BEACON
Core Monitoring and
Operations Support System

BEACON
Core Monitoring and
Operations Support System
(WCAP-12473-A)
Addendum 1

**SUBJECT: ACCEPTANCE FOR REFERENCING OF LICENSING TOPICAL REPORT
WCAP-12472-P-A, ADDENDUM 1, "BEACON-CORE MONITORING AND
OPERATION SUPPORT SYSTEM"**

SAFETY EVALUATION BY THE OFFICE OF NUCLEAR REACTOR REGULATION

Figure 8-1

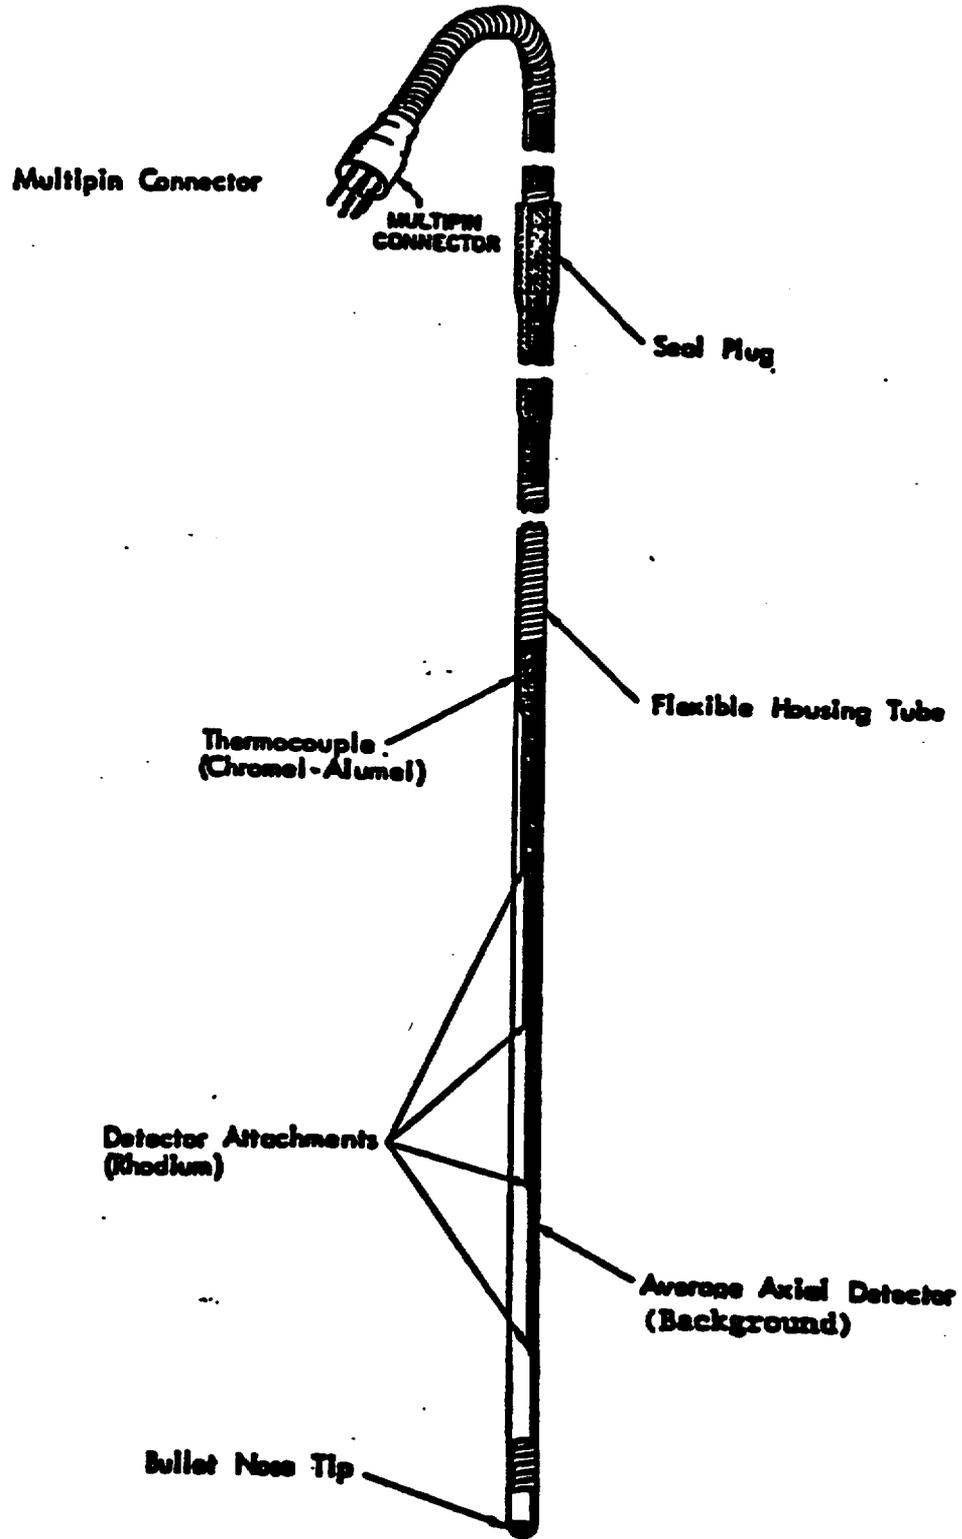
WCAP-12472-P-A contains information pertaining to the detector system description and qualification for the movable incore detector system. Please provide similar information for the fixed incore detector system.

As an example, the detector assembly and the detector layout of a typical 217 assembly CE plant is shown in Figure 8.1 through Figure 8.3.
